Memorandum

SUBJECT: CHARCOT AVENUE EXTENSION

SUPPLEMENTAL

SUBJECT: Responses to Comments from BAAQMD on the Supplemental HRA for the Charcot Roadway Project
Job#17-229

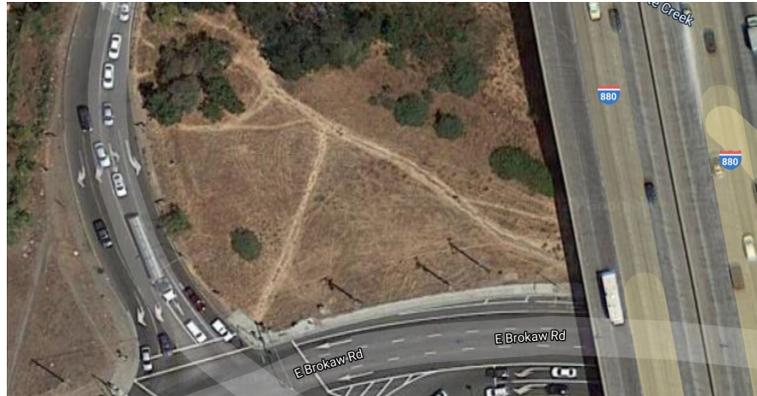
Response BB.16: The comment is correct in that kindergarten drop-off/pick-up was not observed. However, the focus of the observation was the later dismissal period which coincides with a greater volume of traffic on adjacent roadways. Traffic volumes during the kindergarten dismissal period at 12:35pm are much less than after 3pm.

Add. Comment BB.16: According to the traffic data provided in the DEIR traffic volumes during the kindergarten dismissal period are actual higher than after 3pm. The response also fails to explain why traffic volumes after 3pm (25 minutes after dismissal time of 2.35pm) are relevant to school pick-up activities. 3pm is also outside of the observation period done for the DEIR.

The intent of Response BB.16 was to point out the reasons why the kindergarten drop-off/pick-up was not observed. Regardless of any debate as to when observations should have taken place, the conclusion of the transportation analysis remains the same, namely that 1) there are no parts of the project that will not comply with current safety/design criteria and 2) the project includes features that will substantially enhance access for both bicyclists and pedestrians.
